IR Number 1.2.119 (Source: MVEIRB)

IR Number 1.2.120

PROJECT		Cameron Hills Project	
TITLE			
Linear Corridor Density Within the CESA, Cameron Hills			
PROJECT No. 03-1322.104		SCALE AS SHOWN	REV. 0
DESIGN	CWL	15 Jan 2004	MAP: 1.2.123
CHECK	BTR	14 Jan 2004	
REVIEW			
Golder Associates Calgary, Alberta

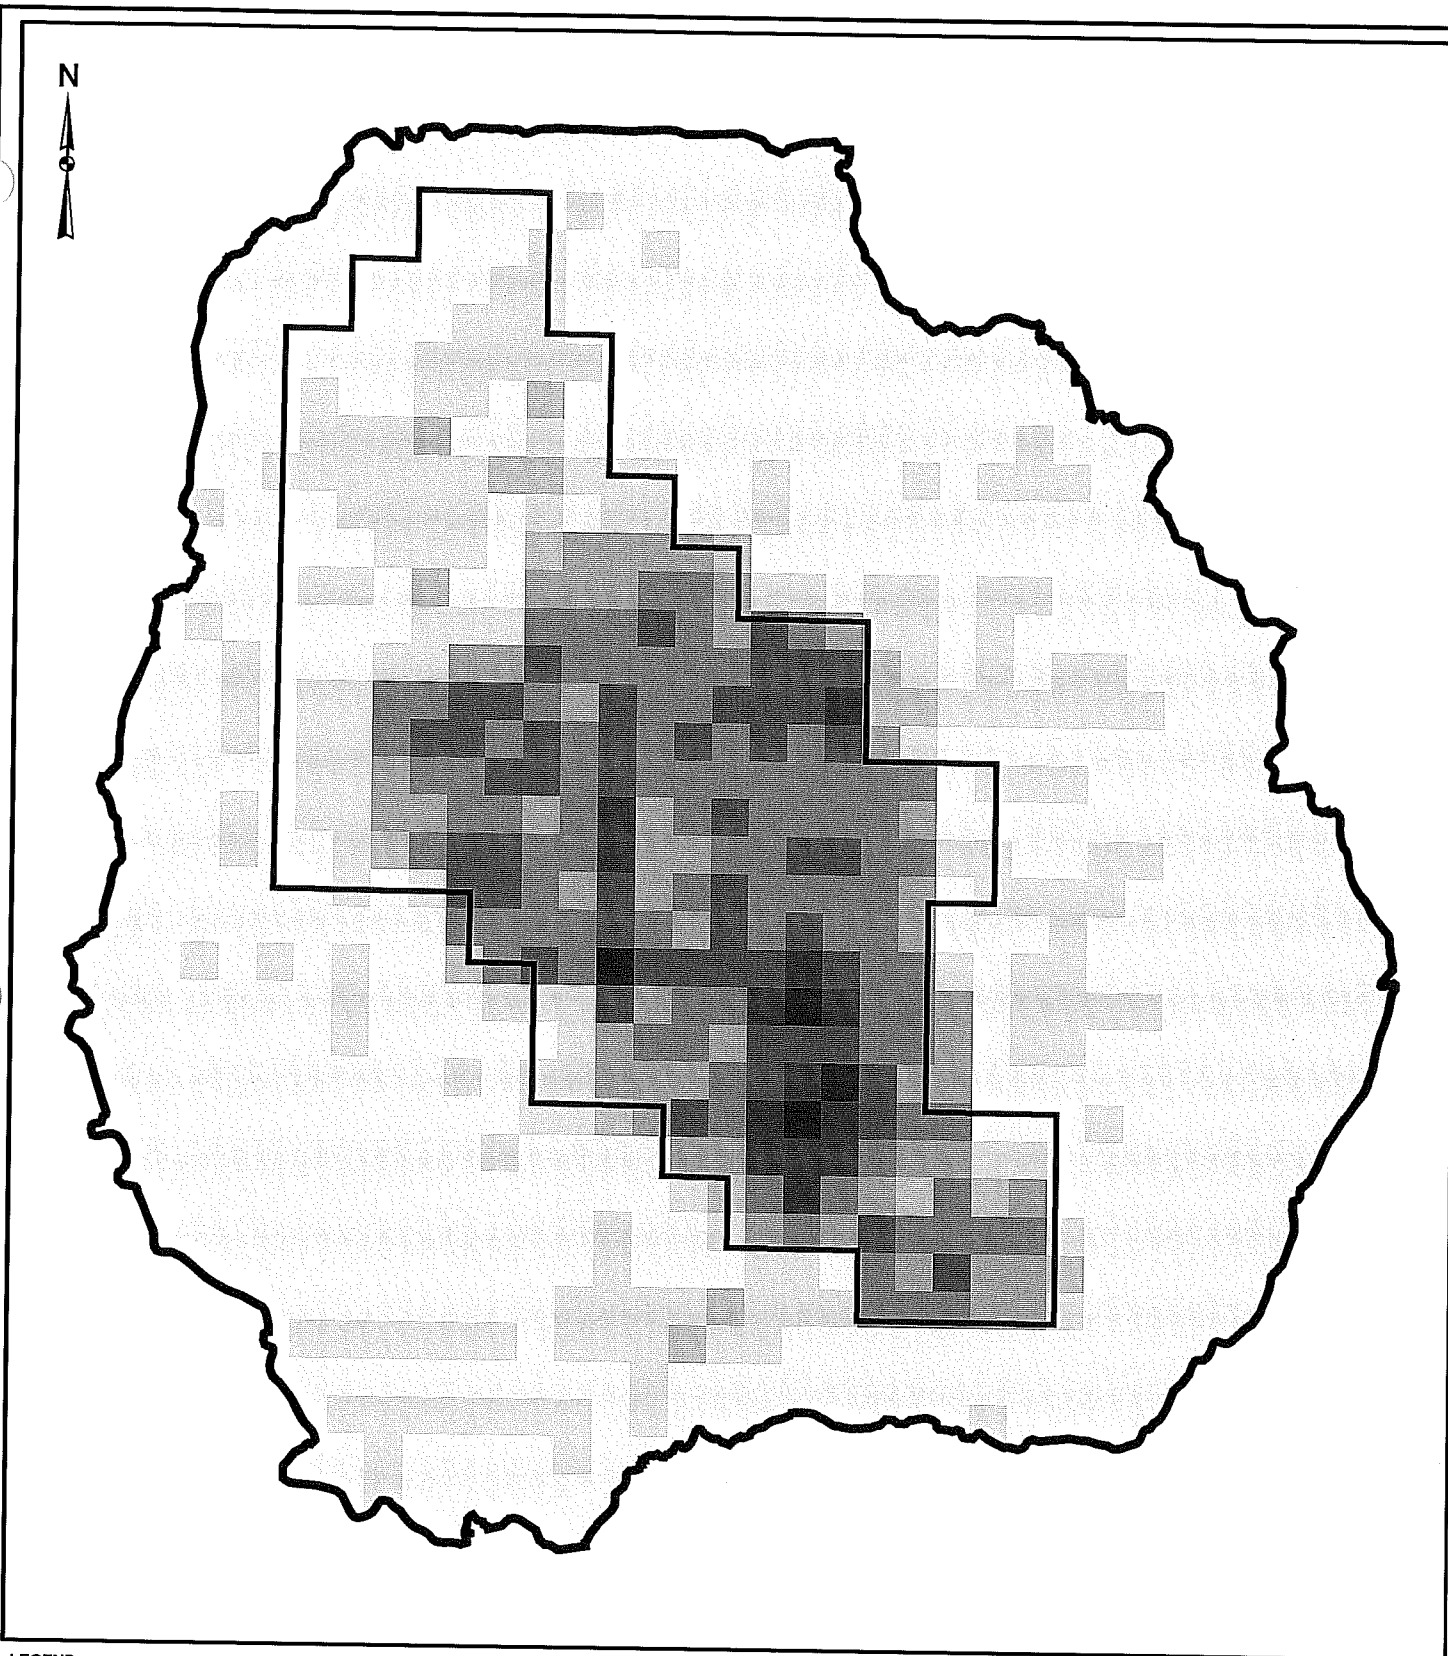
- a) *Provide a spatially-explicit map displaying linear corridor density variation throughout the terrestrial CESA.*
- b) *The zones of influence for caribou included in Table 7.6-8, defined there as the maximum distance that a disturbance will potentially affect a species, are attributed to Dyer (1999). Please discuss why a 250 m zone of influence was used for wellsites, when Dyer (1999) reported the maximum zone of influence for wells to be 1000 m. Please discuss why a 1000 m zone of influence was used for access, when Dyer (1999) reported the maximum zone of influence for roads to be 500 m. Please discuss why a 100 m zone of influence was used for utility corridors (including seismic lines), when Dyer (1999) reported the maximum zone of influence for seismic lines to be 250 m.*

- a) Map 1.2.123 is attached.
- b) The Zones of Influence (ZOI) used in the DAR to determine sensory disturbance impacts on caribou, used the results of Dyer (1999) to help define the ZOI. Within Dyer (1999), it is important to note, that caribou movements were examined during five biological time periods (early winter, late winter, calving, summer, rut) and that "avoidance" did not necessarily indicate no use of a development buffer by caribou. Therefore, for the sensory disturbance assessment, the percentage of expected use by caribou within development buffers (see Figures 3-7, 3-8, 3-9, 3-10 and 3-11 from Dyer (1999)) were used to delineate Disturbance Coefficients. For example, if 100% of expected use of a buffer was displayed by caribou within a figure, it was assumed to have a DC of 1. If only 50% of expected use of a buffer was displayed by caribou, than that distance was given a DC of 0.5, and so on.
